**From:** Caverly, Jill  
**Sent:** Monday, August 31, 2009 1:19 PM  
**To:** Quinn, John  
**Cc:** FermiCOL Resource  
**Subject:** Fermi 3 Cooling Tower Move  
**Attachments:** Site Layout Changes for Cooling Tower exEP.pdf; Site Layout Changes for Cooling Tower EP.pdf

Subject: Detroit Edison Company Submittal of Final Safety Analysis Report (FSAR) and  
Emergency Plan Changes Associated with Revised Fermi 3 Site Plan

**Summary of Fermi 3 FSAR Changes & Fermi 3 FSAR Markup**

Figure 2.4-215 Final Grade Drainage Areas

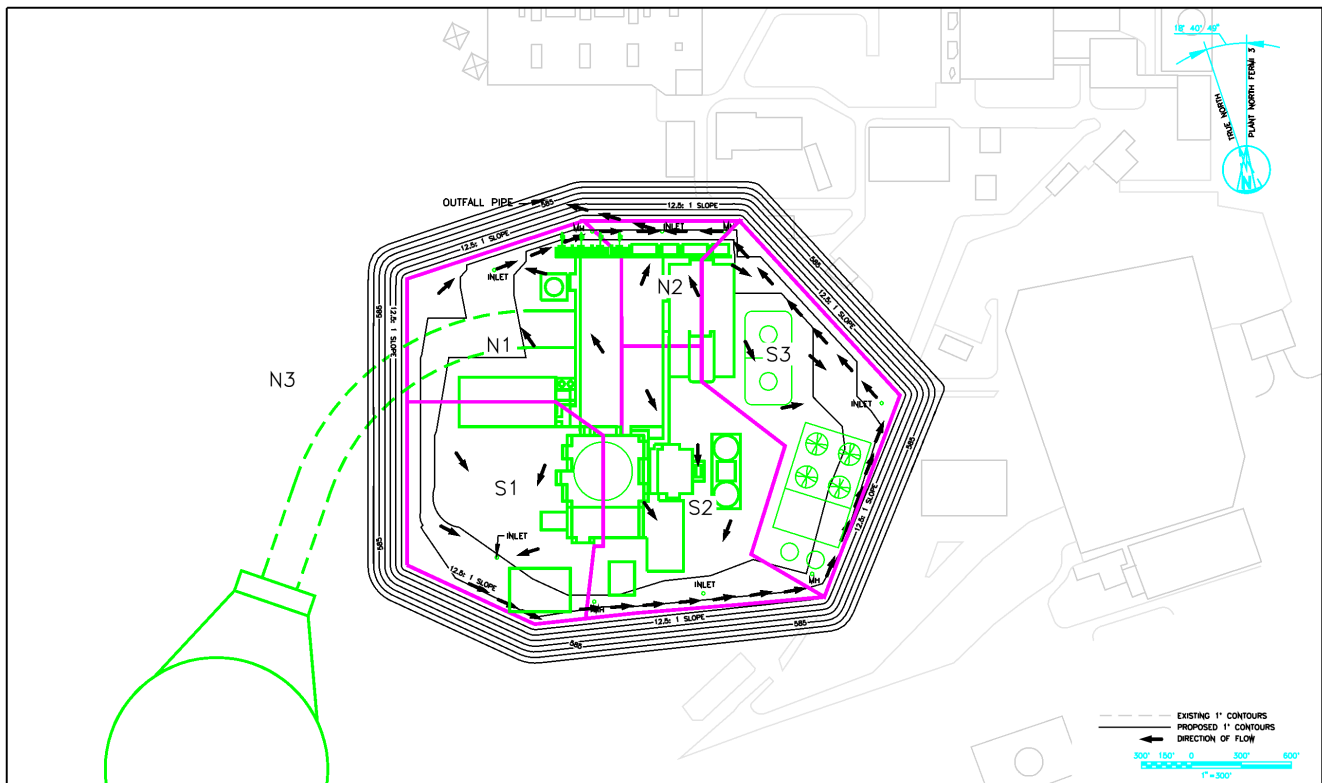
2.4	Hydrology	<p>Section 2.4.2, including Tables 2.4-213 and 2.4-214 are updated to reflect the changes to areas of the sections of the Fermi 3 grade elevation made due to moving the Service Water/Water Treatment (SW/WT) Building.</p> <p>Figure 2.4-211 is revised to reflect new site layout.</p> <p>Figures 2.4-215 and 2.4-217 are revised to</p>

FSAR Chapter	Sections Impacted	Topics	Comments
			<p>reflect location change for SW/WT Building.</p> <p>Figure 2.4-218 is revised to reflect the new location for the CIRC System NDCT.</p>

Figure 2.5.1-235 Site Exploration Plan

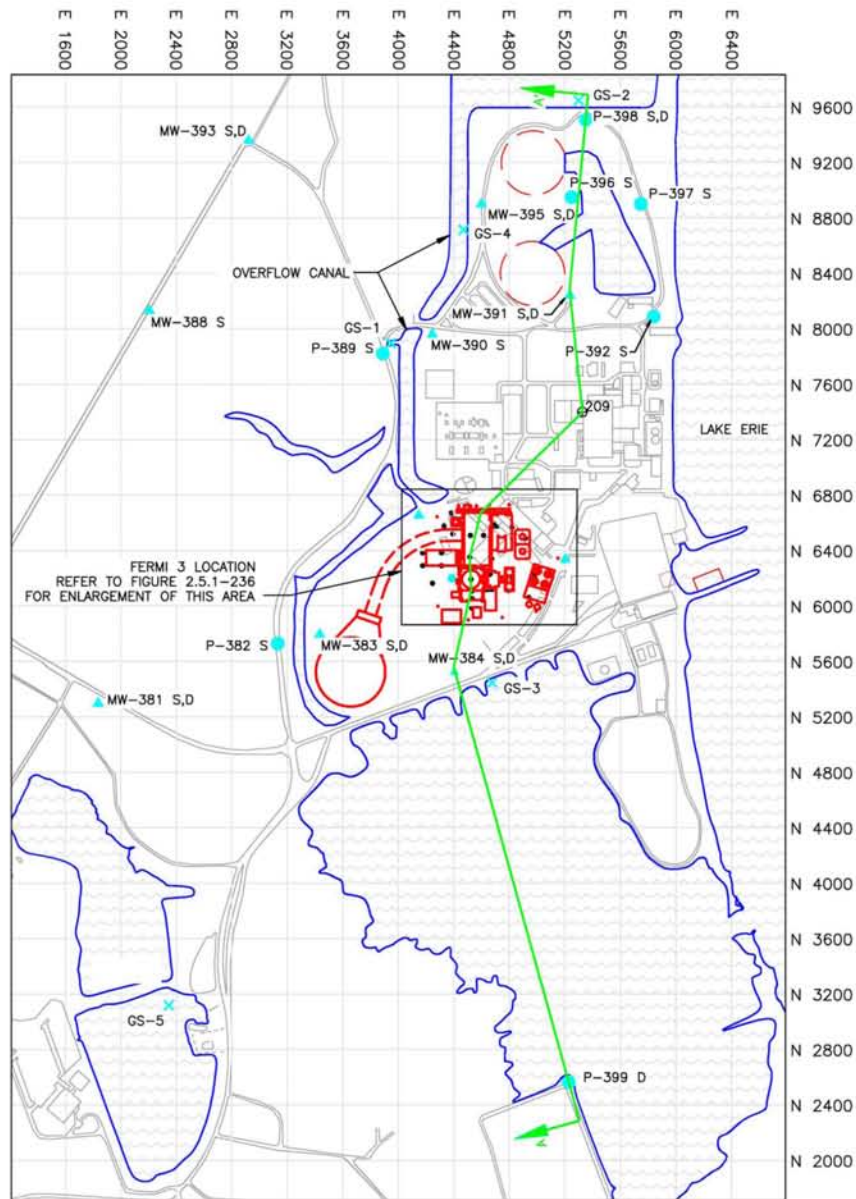
2.5	Geotechnical	Figures 2.5.1-235 and 2.5.1-236 are revised to reflect the new locations of the CIRC System NDCT and SW/WT Building.
3	No Impact		
4	No Impact		
5	No Impact		
6	No Impact		
7	No Impact		
8	Section 8.2	Offsite Power Systems	<p>Sections 8.1 and 8.2 are revised to reflect the new location for the Fermi 3 switchyard.</p> <p>Figure 8.2-201 is revised to reflect the new one-line diagram for the Fermi 3 switchyard.</p> <p>Figure 8.2-202 is deleted as the location of the Fermi 3 switchyard. The Fermi 3 switchyard is adequately depicted on the revised Figure 2.1-204 and the description of the pathway for the transmission lines from the Fermi 3 switchyard is adequately described in Section 8.2.</p>
9	Appendix 9A	Fire Hazards Analysis	Figure 9A.2-33R revised to reflect location change for SW/WT Building.

Figure 8.2-202 345 kV Switchyard Arrangement

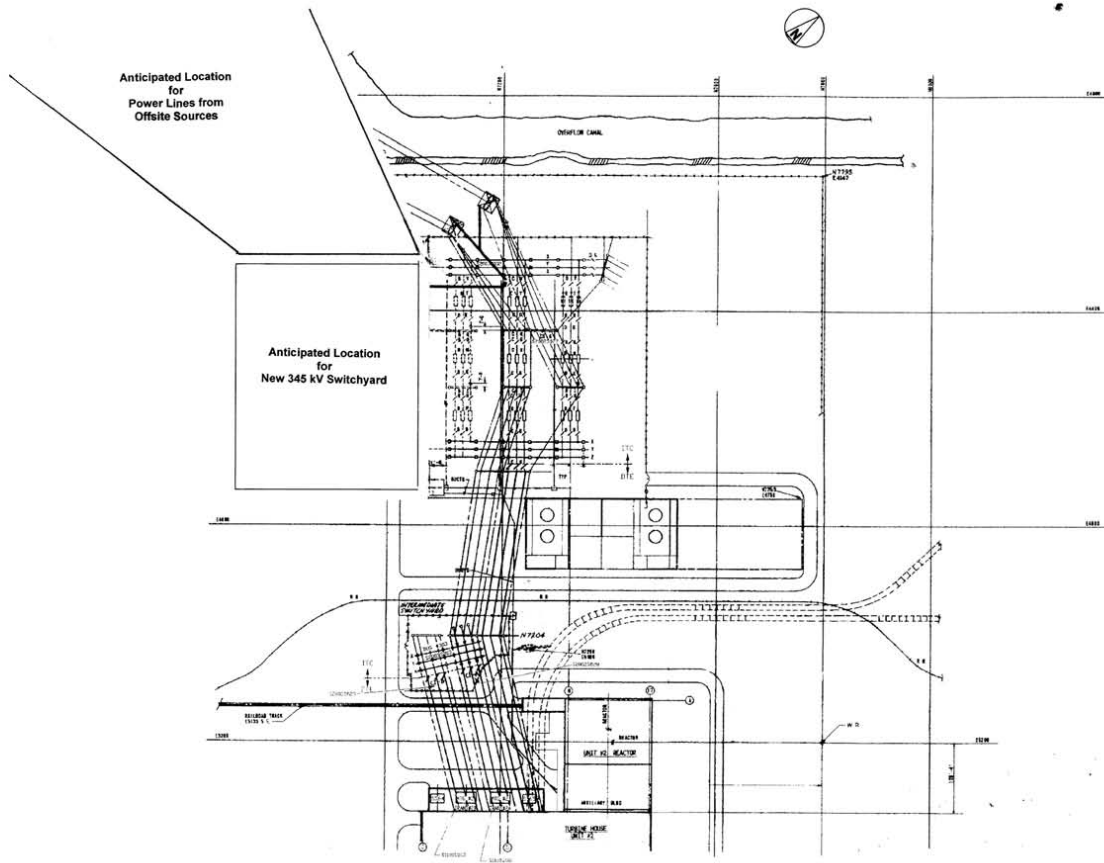
FSAR Chapter	Sections Impacted	Topics	Comments
1	1.7	Drawings	Table 1.7-201 is revised to remove Figure 8.2-202.
	1.8	Interface with Standard Design	Table 1.8-202 (Sheet 2 of 2) is revised to identify a CDI item has been added to Section 10.4.5.6.
2	2.1	Site Layout – General Information	Figures 2.1-203 and 2.1-204 are revised to reflect the revised site plan.
